ADDENDUM NO. 1
TO THE
DRAWINGS AND SPECIFICATIONS
FOR THE
17TH Street Reconstruction

Issued From: The City of Bloomington
Planning and Transportation Department
Post Office Box 100
401 North Morton Street, Suite #130
Bloomington, Indiana 47402

Issue Date: January 24th, 2019

SCALE 1"=40'	BRIDGE FILE N/A
	DESIGNATION N/A
SURVEY BOOK N/A	SHEETS 43 of 100
CONTRACT N/A	PROJECT 17TH STREET RECONSTRUCTION

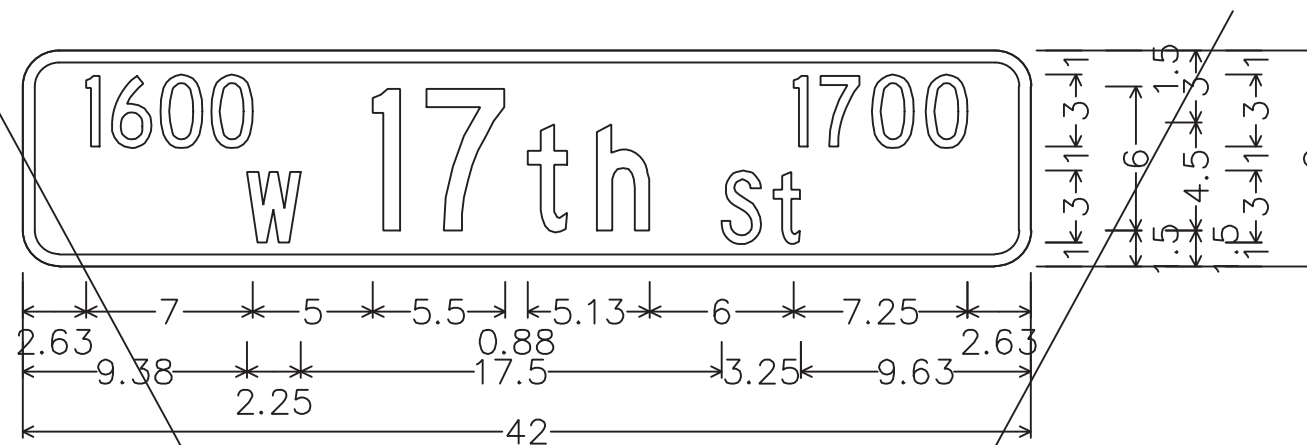
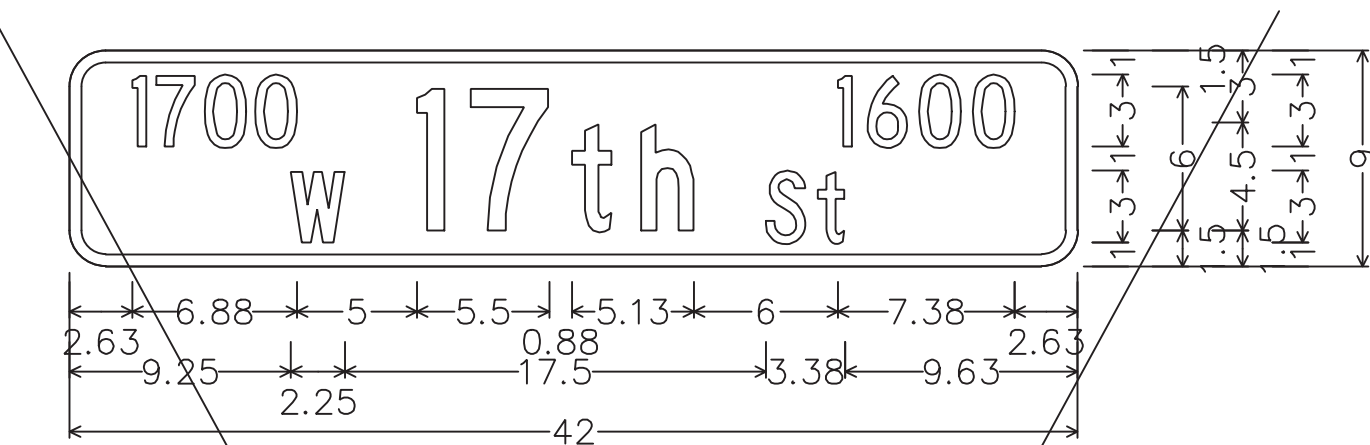
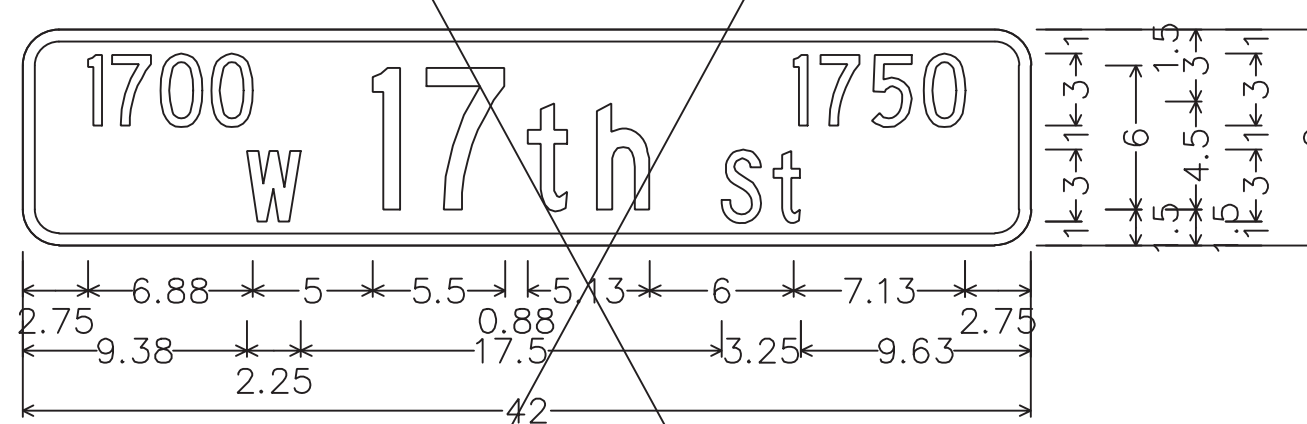
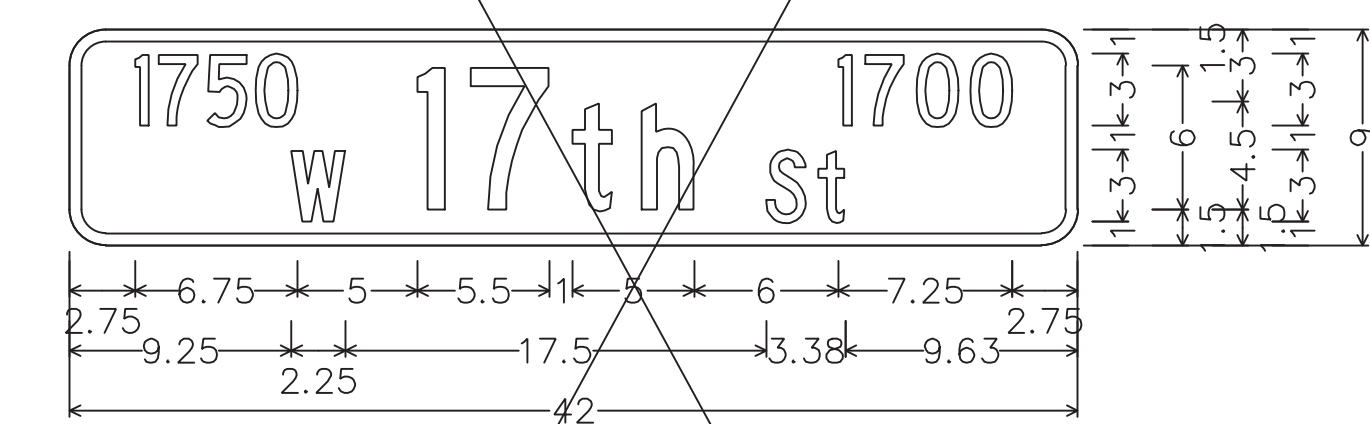
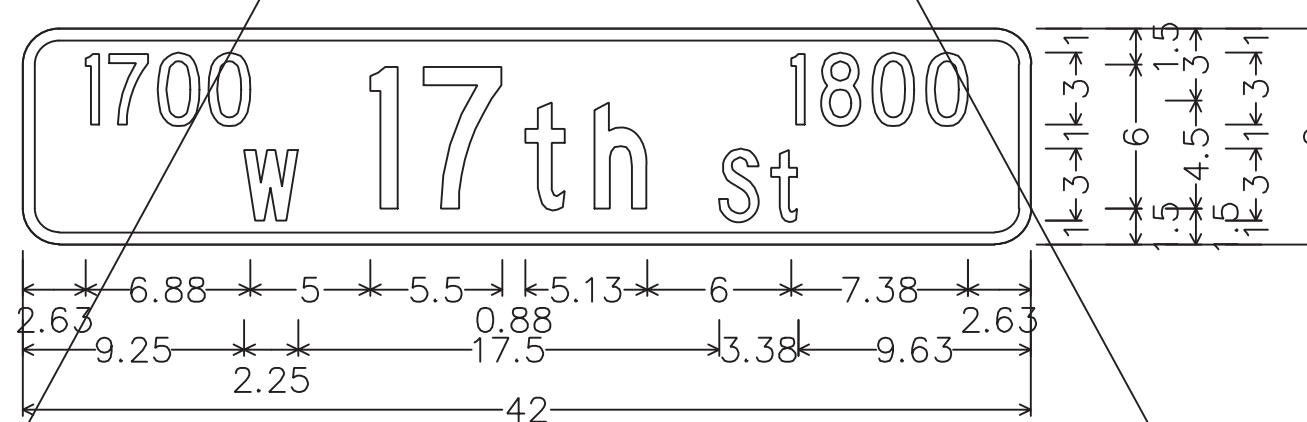
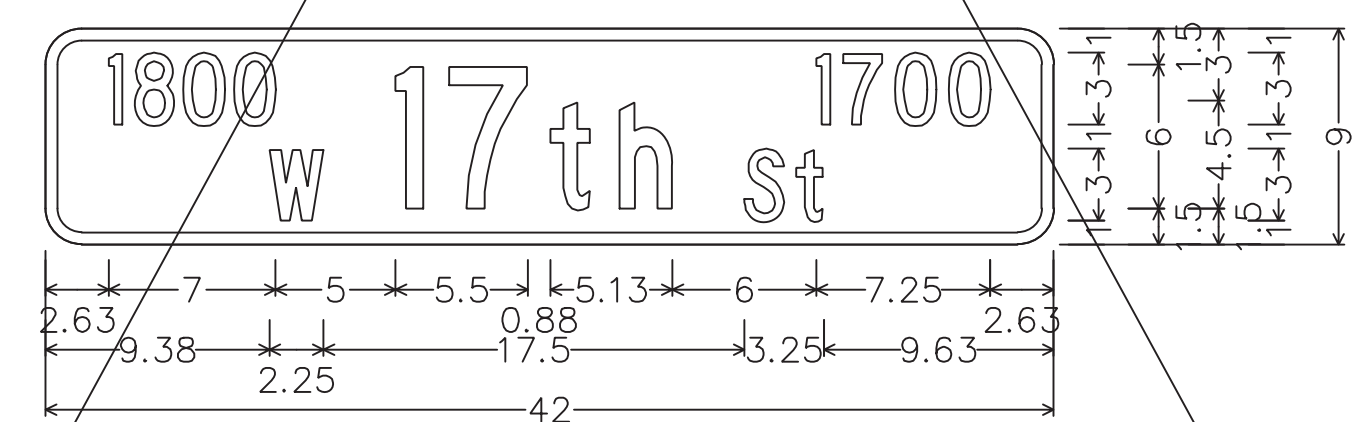
The City of Bloomington Standard Traffic Street Name Sign Details, Standard Drawing No. – SS-1 dated 8/21/2018, is attached with this Addendum. The provided standard drawing shall be the basis for the shop drawing development of the proposed street signs and shall override the details as shown on sheets 43 & 44 of the plans. Shop drawings for the proposed street signs shall be submitted to the city for review and approval prior to manufacturing. Revised Plan sheets 43 & 44 have been added per this addendum.

See City of Bloomington Standard Drawing No. SS-1 included in Addendum #1.
 Use Street Name and Block information as shown with the format as noted on
 Standard Drawing No. SS-1 to develop new shop drawings.
 Shop drawing to be submitted for review and approval prior to manufacturing
 and installation of signs.
